UNITED STATES PATENT AND TRADEMARK OFFICE

APPLICATION NO.	FILING DATE	FIRST NAMED INVENTOR	ATTORNEY DOCKET NO.	CONFIRMATION NO.
09/838,348	04/19/2001	Randall W. Ojanen	K-1786	2490
7590		07/10/2006	EXAMINER	
Kennametal Inc.		SINGH, SUNIL		
P.O. Box 231		ART UNIT		
Latrobe, PA 15650		PAPER NUMBER		
		3673

Office Action Summary

DETAILED ACTION

Fig. 15

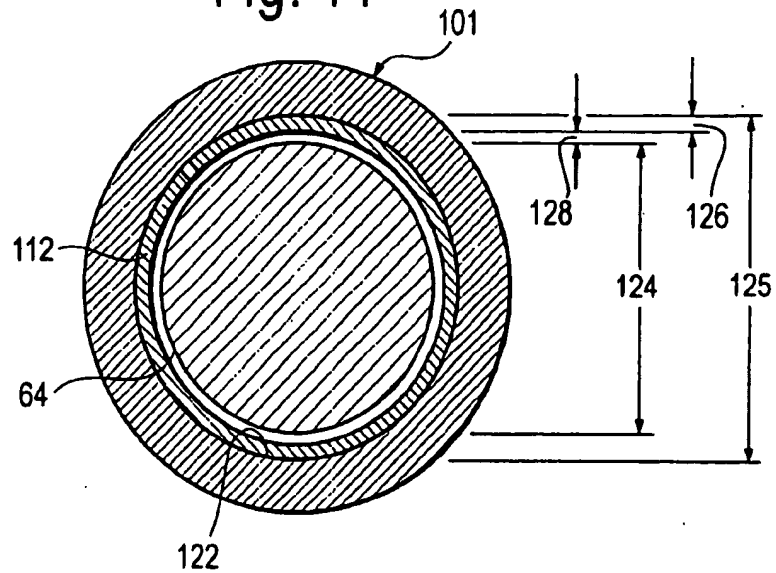
a cutting tool (10") a retainer sleeve (38") carried by the cutting tool, and including at least one radially outward protruding surface (31); wherein said retainer has a cylindrical circumference and a thickness dimension, the amount of radial projection of said protruding surface beyond the cylindrical surface of the retainer is between about 15 percent and about 30 percent of the thickness dimension of said retainer (see attached marked up Fig. 15).
